Well Name: POKER LAKE UNIT 26 BD	Well Location: T25S / R30E / SEC 26 / SWNE / 32.10217 / -103.849242	County or Parish/State: EDDY / NM
Well Number: 126H	Type of Well: CONVENTIONAL GAS WELL	Allottee or Tribe Name:
Lease Number: NMLC063875	Unit or CA Name:	Unit or CA Number: NMNM71016AU
US Well Number: 3001547979	Operator: XTO PERMIAN OPERATING LLC

Sundry ID: 2873723

Type of Submission: Notice of Intent	Type of Action: APD Change
Date Sundry Submitted: 09/16/2025	Time Sundry Submitted: 09:00
Date proposed operation will begin: 09/16/2025

XTO Permian Operating LLC respectfully requests to make the following changes for well record clean up:

ACREAGE DEDICATION PLATS

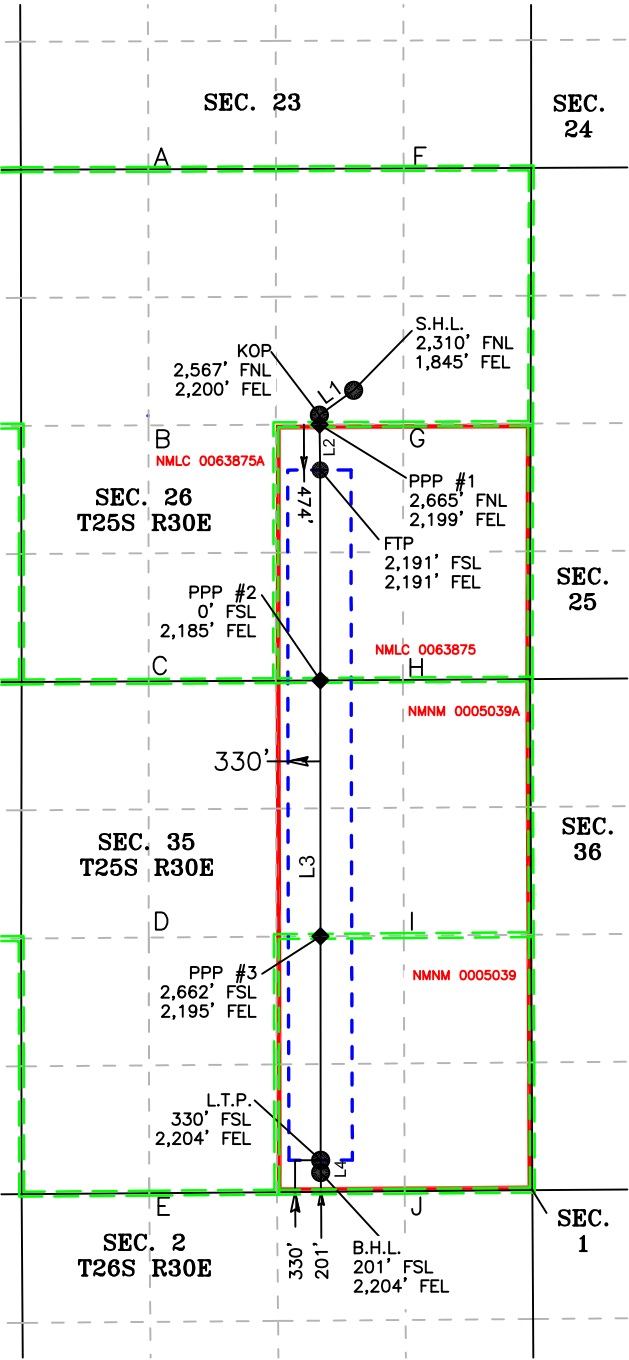
Dedicated acres: f/240 t/480

FTP: f/ 2567 FNL & 2200 FEL t/ 2191 FSL & 2191 FEL, Sec 26-25S-30E; Lease NMLC0063875

Attachments: Updated C-102 on new required form. No new surface disturbance.

Dedicated Acres 480	Infill or Defining Well INFILL	Defining Well API 30-015-47989	Overlapping Spacing Unit (Y/N) N	Consolidation Code U
Order Numbers.			Well setbacks are under Common Ownership: ☒ Yes ☐ No

UL J	Section 26	Township 25 S	Range 30 E	Lot	Ft. from N/S 2,191' FSL	Ft. from E/W 2,191' FEL	Latitude 32.099892	Longitude -103.850378	County EDDY
---------	---------------	------------------	---------------	-----	----------------------------	----------------------------	-----------------------	--------------------------	----------------
